# ILC CFS AD&I Daresbury Lab

## Summary

J.Osborne / V.Kuchler / A.Enomoto

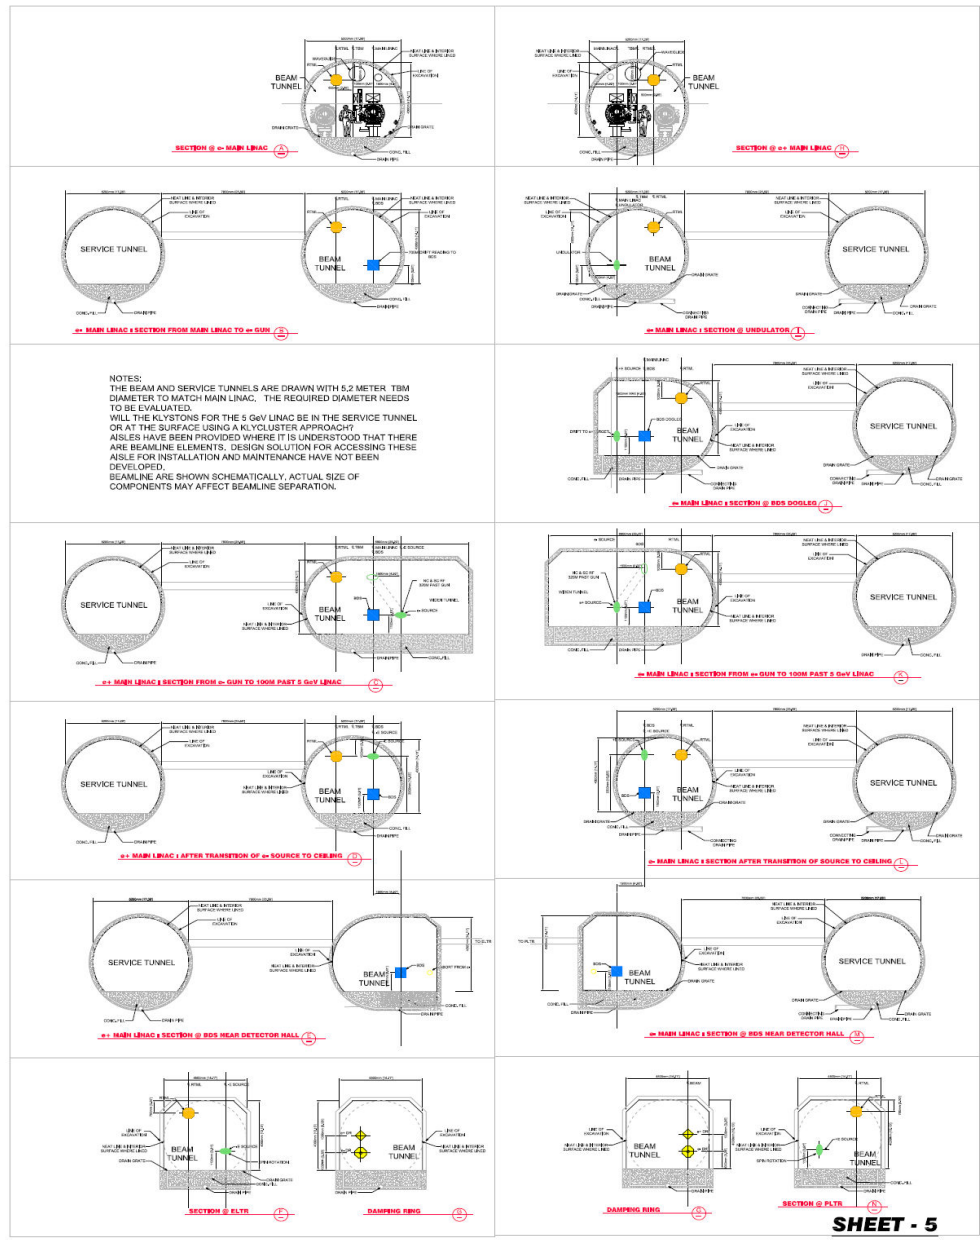
NOTES:  
 THE BEAM AND SERVICE TUNNELS ARE DRAWN WITH 5.0 METER TBM DIAMETER TO MATCH MAIN LINAC. THE REQUIRED DIAMETER NEEDS TO BE EVALUATED.  
 WILL THE KLYSTRONS FOR THE 9 GeV LINAC BE IN THE SERVICE TUNNEL OR AT THE SURFACE USING A KLYCLUSTER APPROACH?  
 AISLES HAVE BEEN PROVIDED WHERE IT IS UNDERSTOOD THAT THERE ARE BEAMLINE ELEMENTS. DESIGN SOLUTION FOR ACCESSING THESE AISLE FOR INSTALLATION AND MAINTENANCE HAVE NOT BEEN DEVELOPED.  
 BEAMLINE ARE SHOWN SCHEMATICALLY. ACTUAL SIZE OF COMPONENTS MAY AFFECT BEAMLINE SEPARATION.

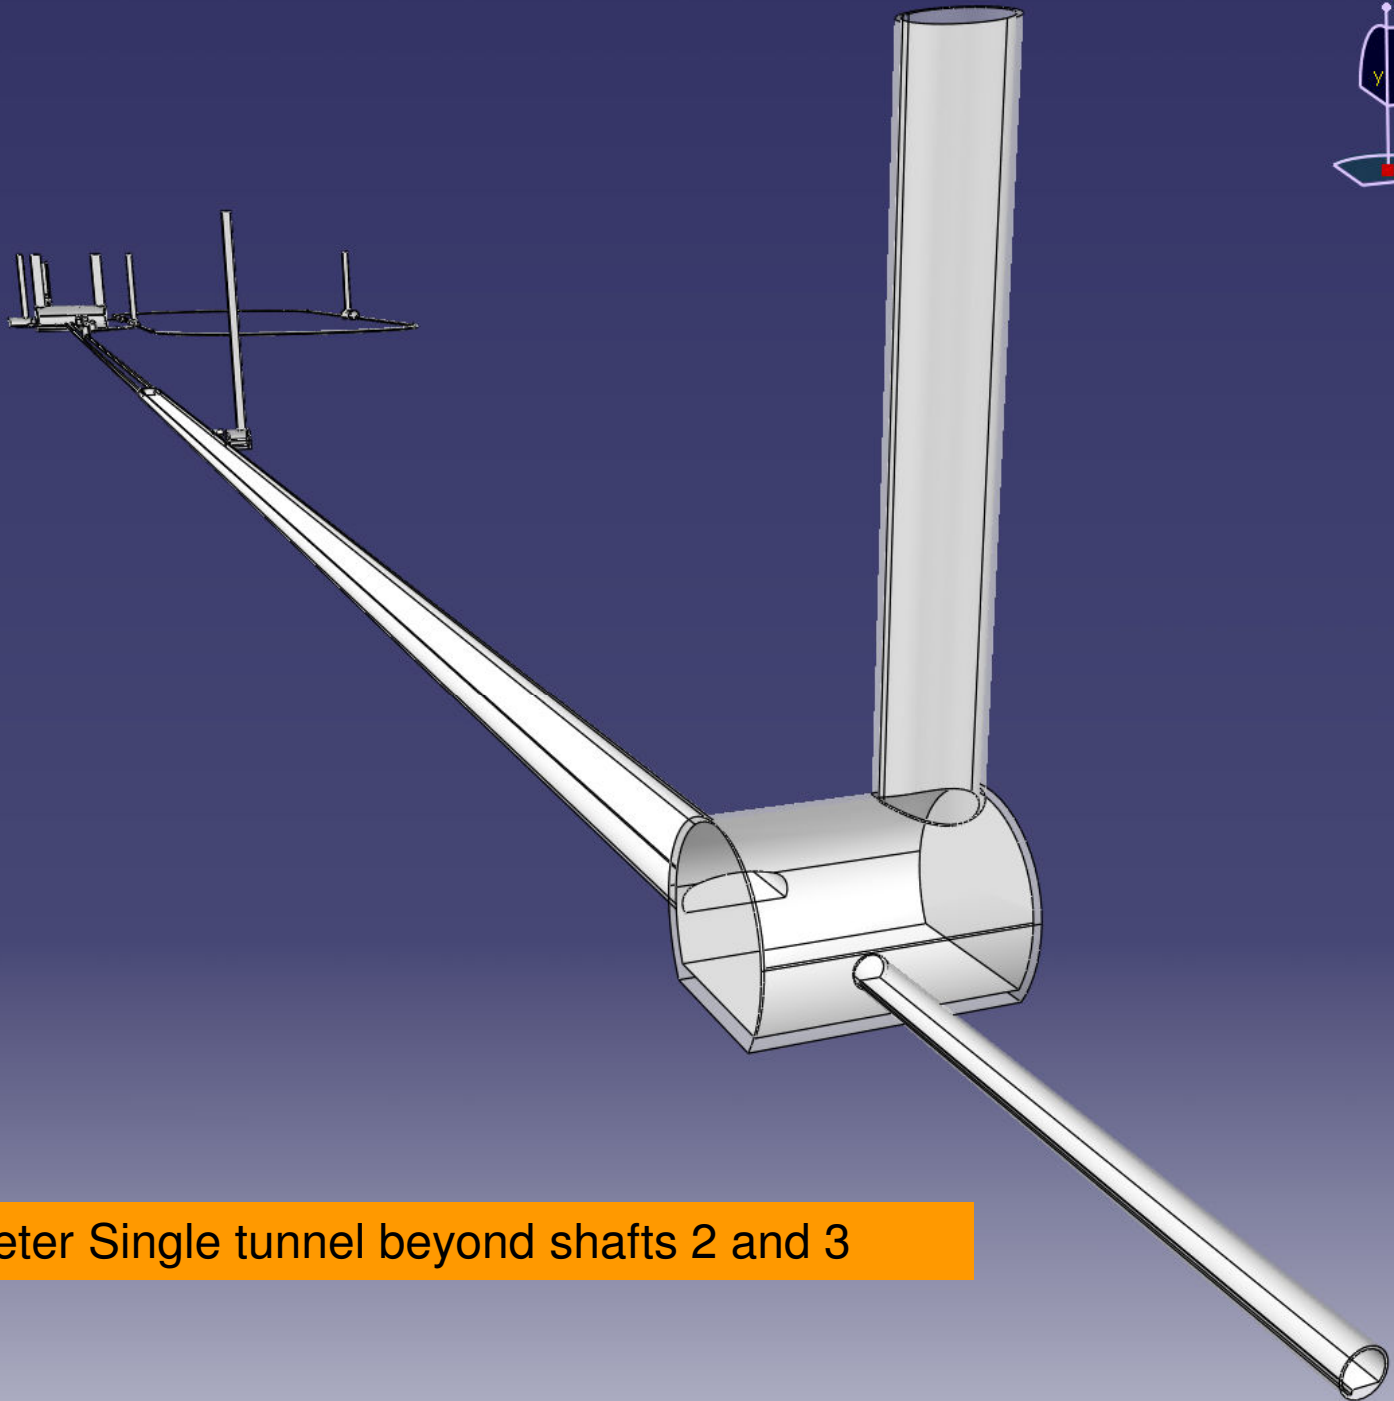
Beam dumps have been added (all cavern dimensions to be reviewed)

# Interaction Region

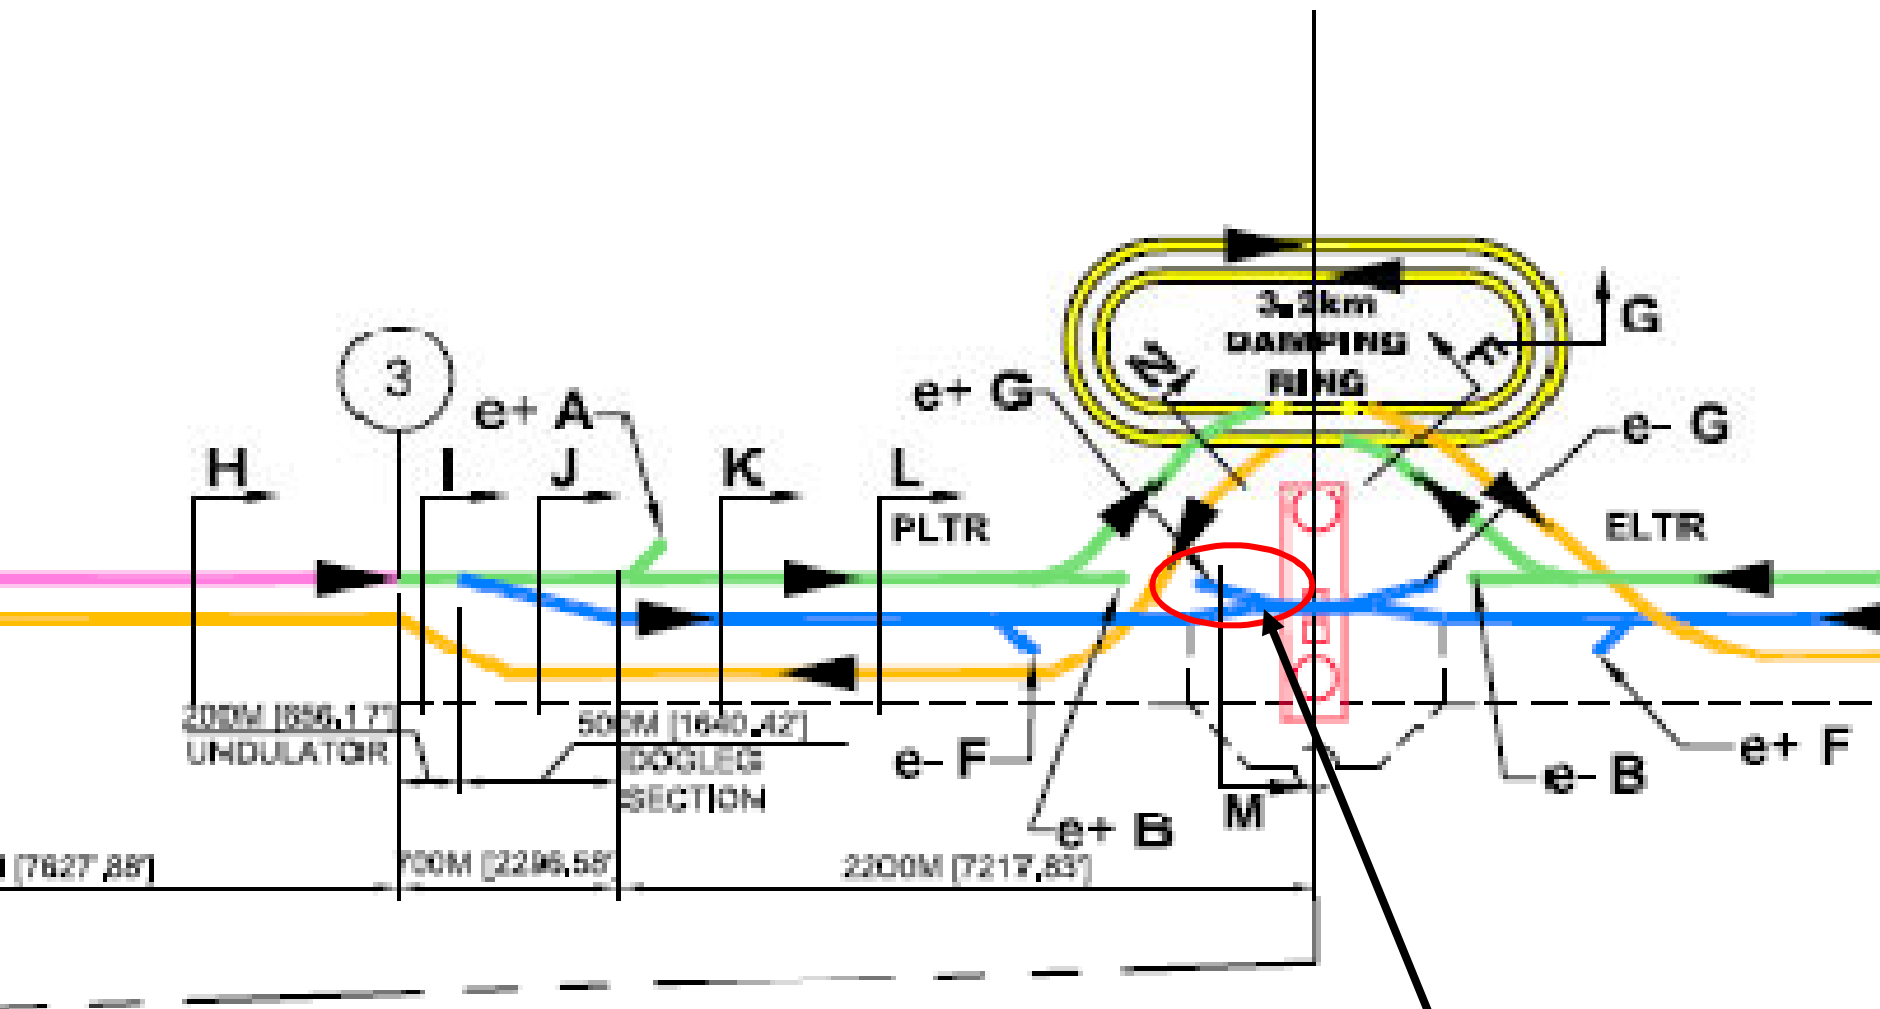
Main Beam dumps need to be moved to 'south side' i.e. opposite side of DR pointing downwards on this drawing.

This means, due to Muon radiation, level of service tunnel needs to be adjusted

Service tunnel revised layout – Dump is below service tunnel

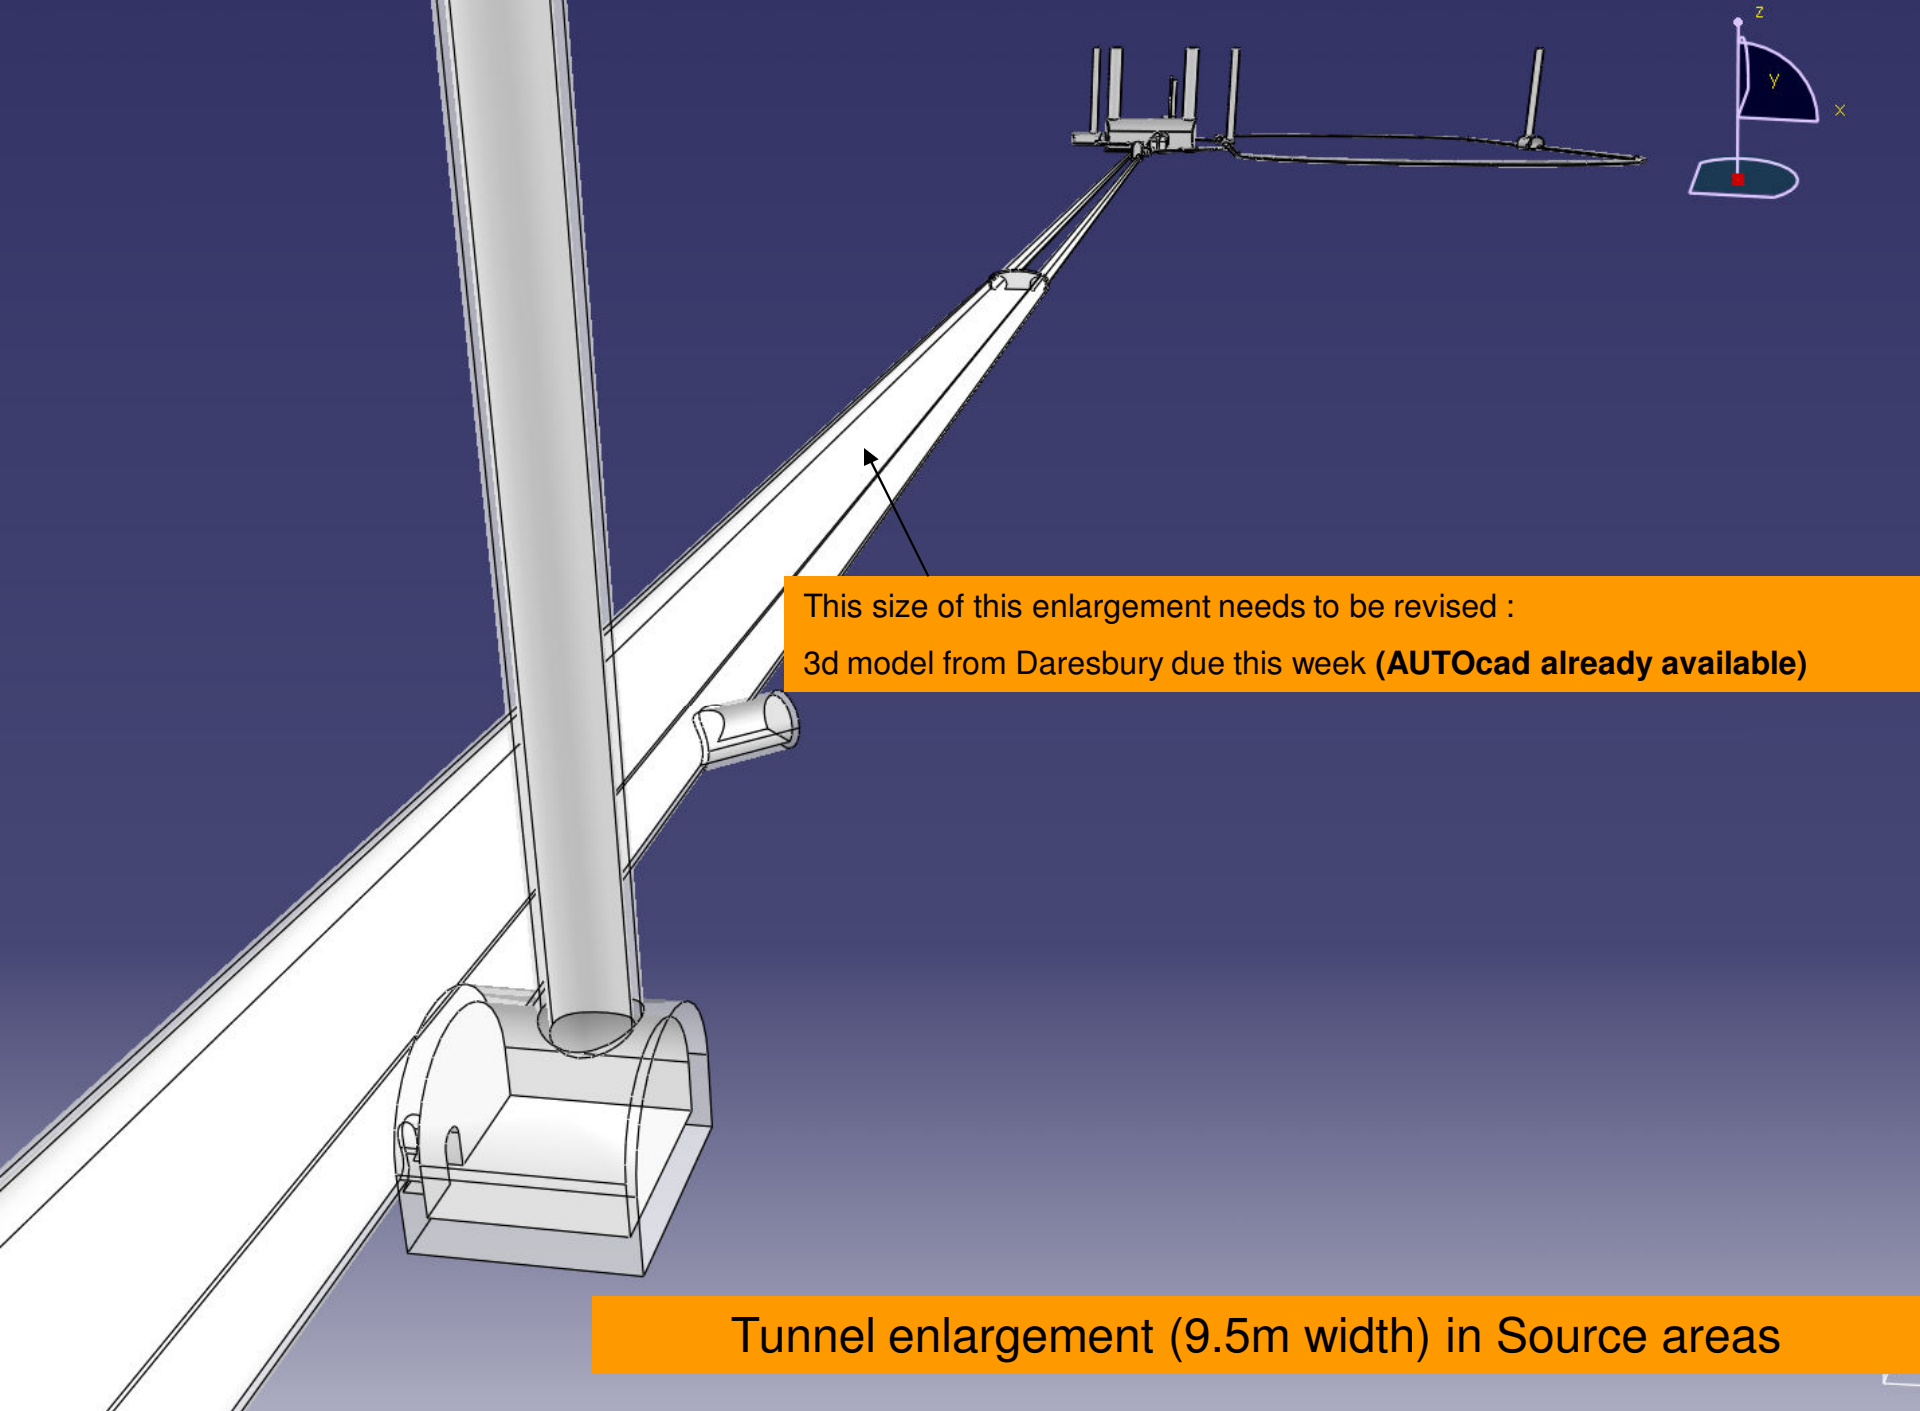
This size of this enlargement needs to be revised :  
3d model from Daresbury due this week (**AUTOCAD** already available)

**SHEET - 2**  
**Draft 8 28 09**

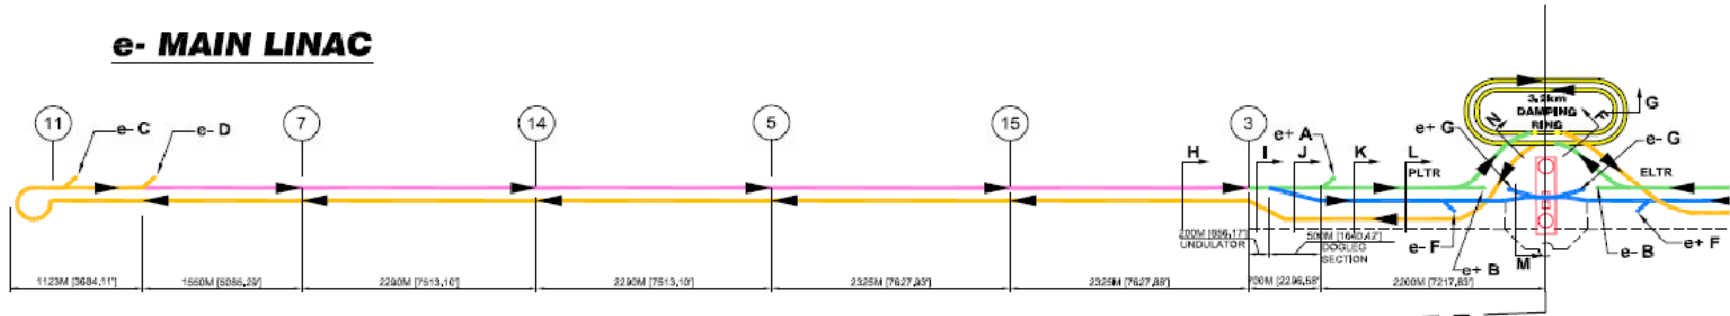
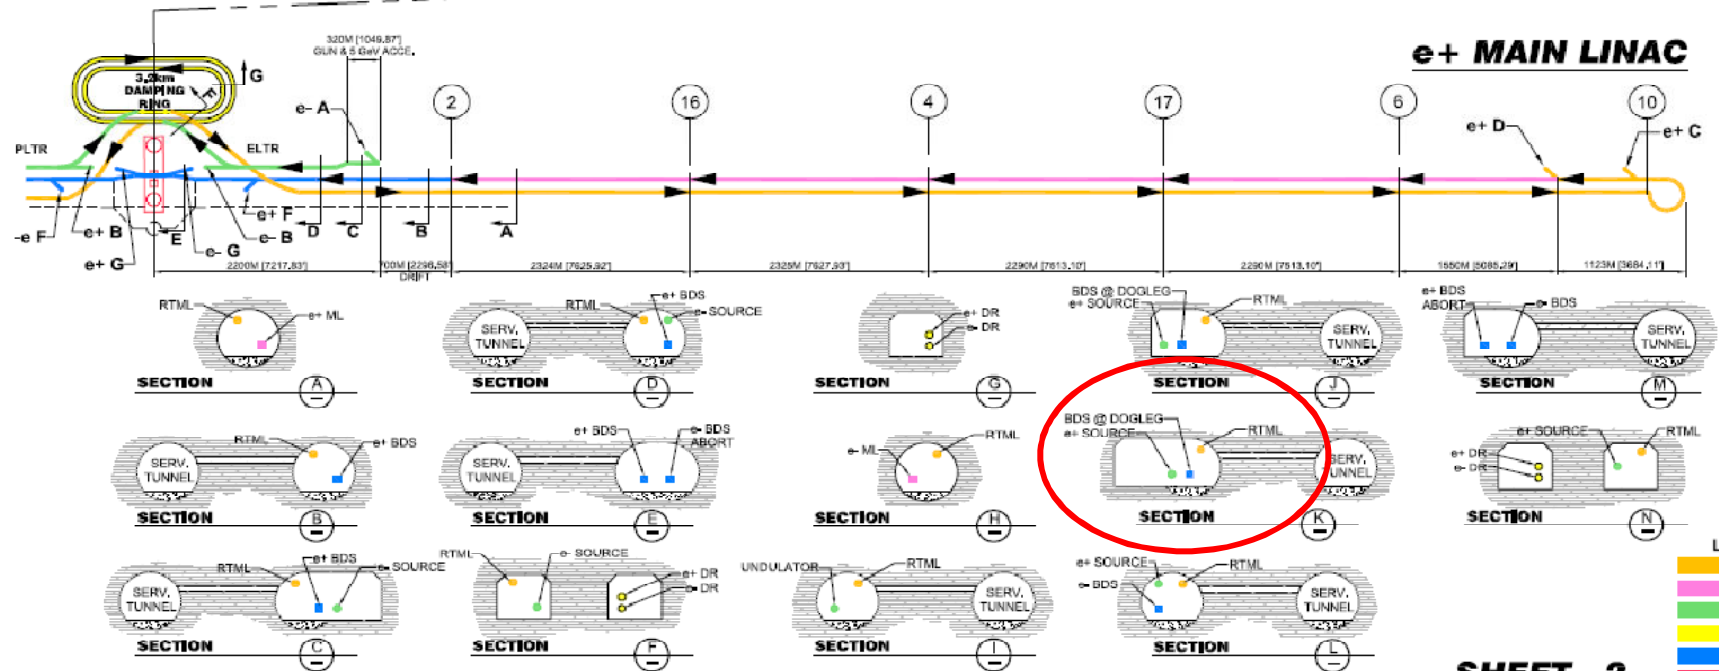
Tunnel enlargement (9.5m width) in Source areas needs to be reviewed (transport corridor on one side is acceptable?)

SECTION @ c- MAIN LINAC

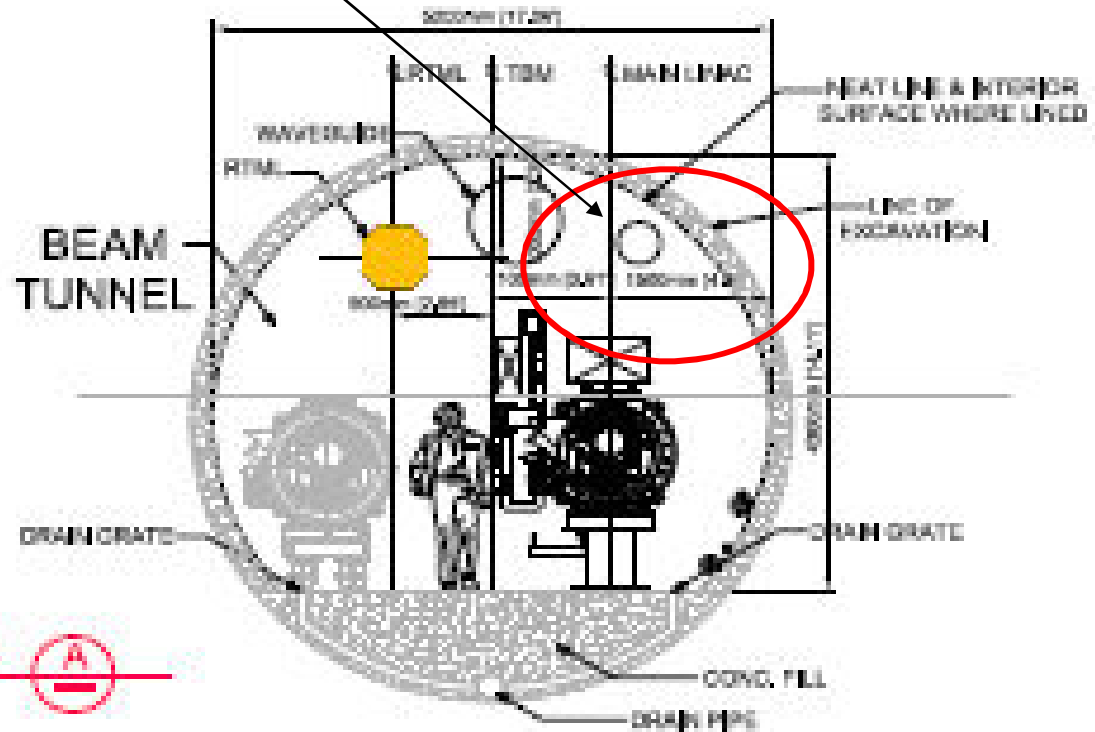
Is cryo vent pipe required in standard tunnel cross section ?
